SUBJECT: SEAT BELT LATCHING MECHANISMS,
INSPECTION AND MODIFICATION

SERVICE BULLETIN

SUBJECT: Possible Improper Latching of Seat Belt Assemblies
FDC-5900-160-4 and FDC-5900-160-6

Sketch A

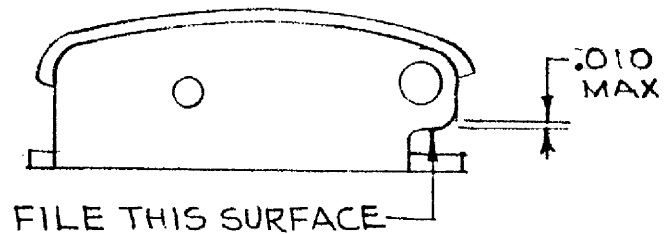
We have found that the release fitting may latch improperly when inserted into the buckle. Improper latching exists if both locking dogs are not engaged with the release fitting. (Note: FAA strength requirements are met even if only one locking dog is engaged.)

To inspect for improper latching, insert the release fitting into the buckle and observe the locking dogs through the rectangular slots in the base of the buckle. If properly engaged, the locking dogs will make contact with the buckle frame base. (Sketch A)

Improper latching may be easily corrected by filing that area of the buckle frame which receives and limits the movement of the release fitting. (Sketch B) The amount of material removed should not exceed .010 inch.
